**Seagate Technology**

Subject: Revision 4 of the Proposal for the Fast 80 Specifications in the SPI-3 Standard

Revision 4 implements the changes agreed to in the 7/14/98 Ad Hoc meeting. No additional changes are introduced except for including the proposed deletion of Note 2 in Table 1. The Fast-10, Fast-20, and Fast-40 timing values in Table 3 were corrected and adjusted.

**Figure 2 - Fast 80 LVD timing measurement points**

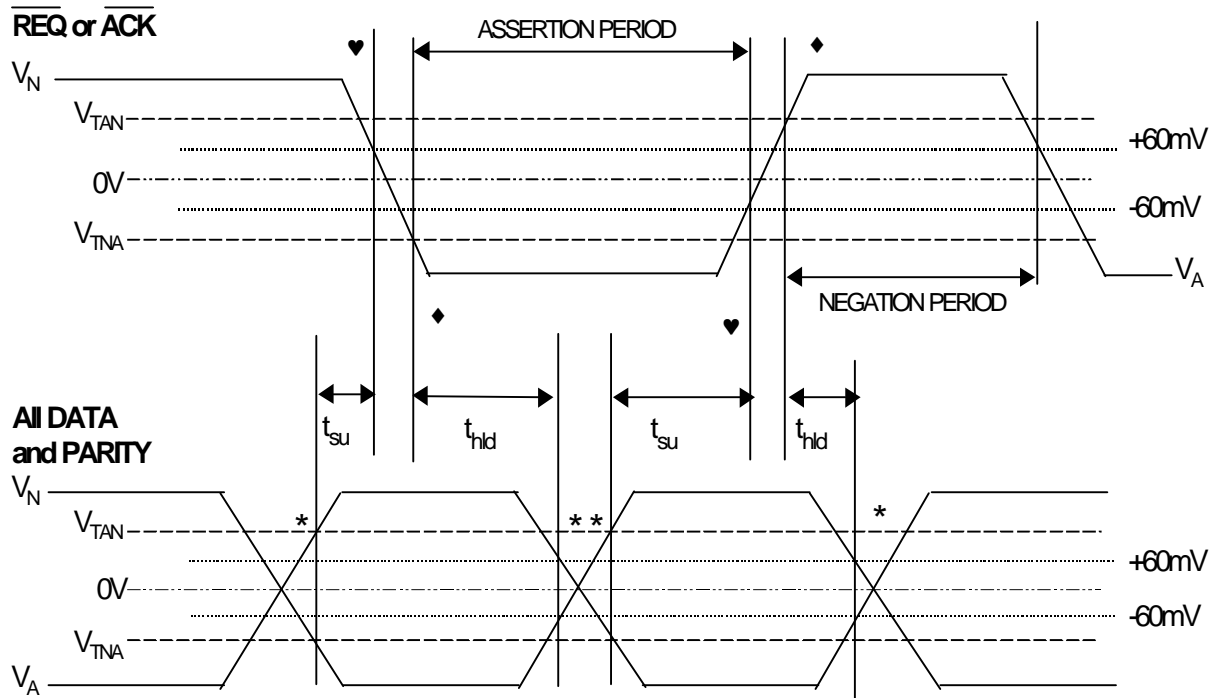
### 1.2.3 LVD ~~>40-MT/s~~ Double Transition

LVD SCSI devices, which have a transfer double transition agreement ~~in the Fast 80 range~~ shall use the measurement points defined in figure 1 for the measurement of the timing values. The rise and fall times for the LVD REQ/ACK signals shall be nominally the same as for the LVD DATA/PARITY signals.

Figure 4 - Fast-80 **Double Transition** System setup and hold timings (all times in ns)

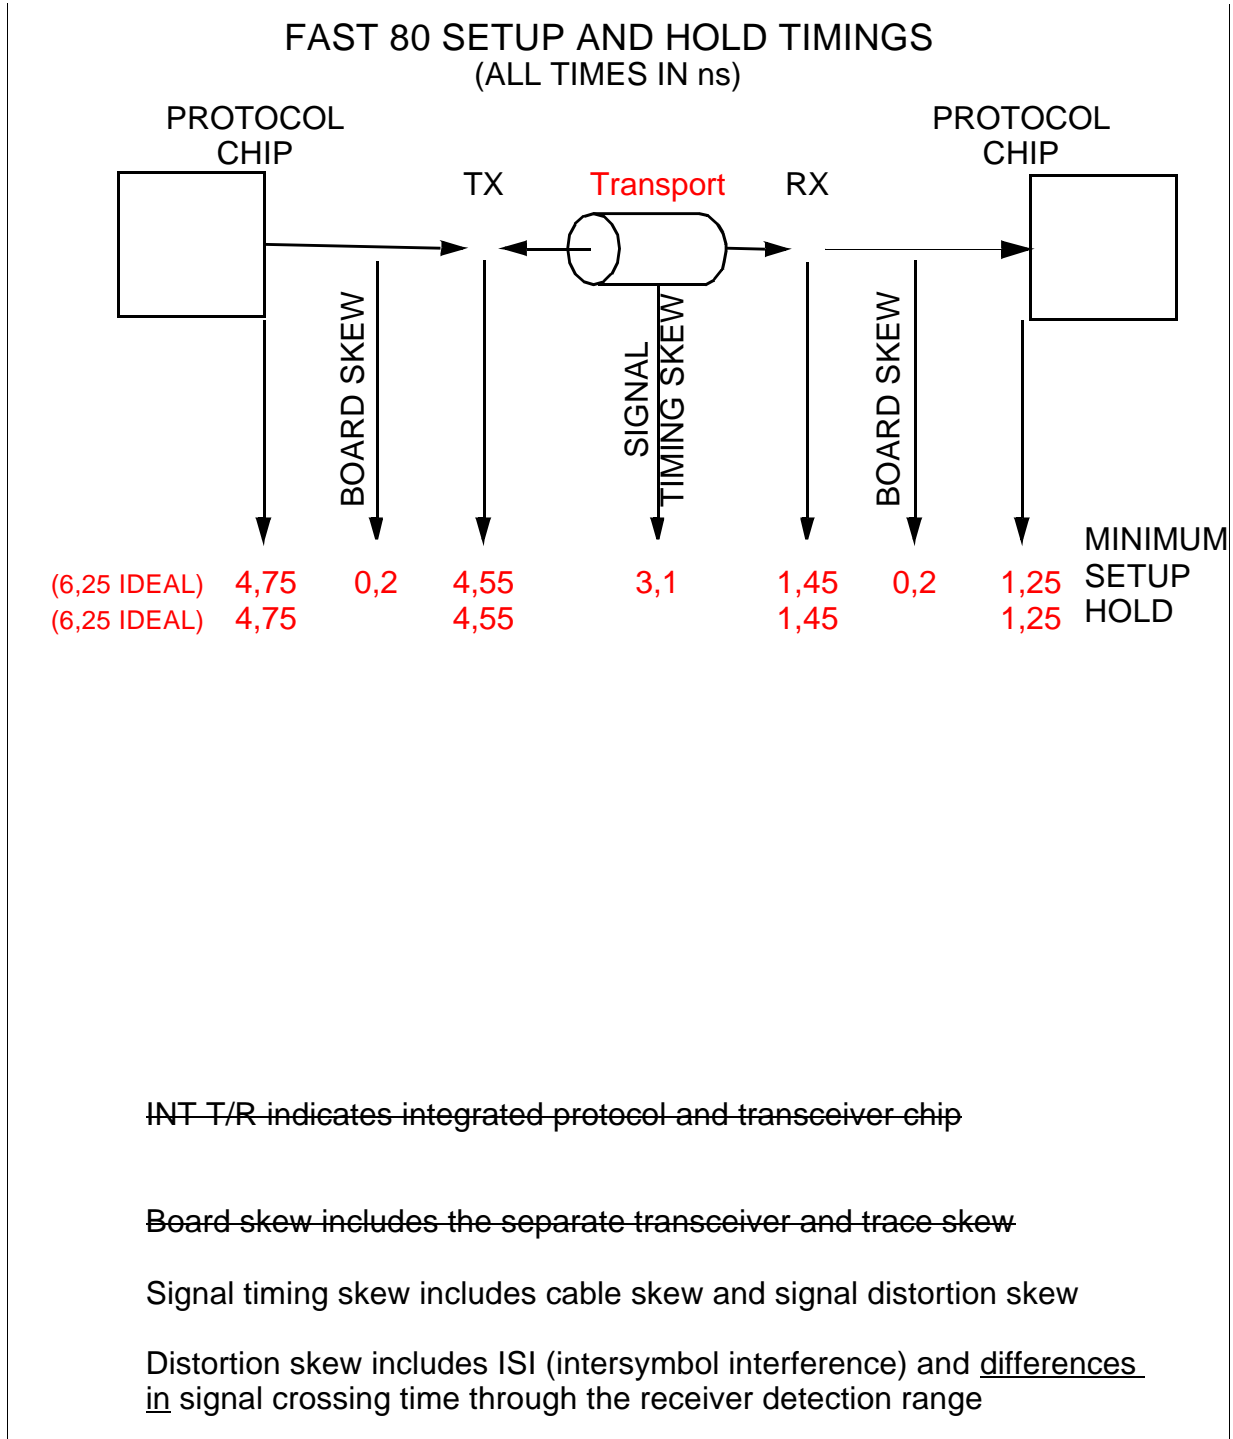
### 1.2.5 Fast-80 data transfer rates

Figure 5 shows how the setup and hold times are calculated for various physical configurations on SCSI devices that support up to and including fast-80 data transfers. The minimum set up and hold timings specified in figure 5 shall be used. Note that these values are different for the driver and the receiver but that the receiver sensitivity provides the threshold points for both. This is required because both extreme cases of **attenuation** need to be covered:

Fast-80 **Double Transition** setup and hold times shall apply if a transfer rate >40 and up to 80 MT/S is negotiated.
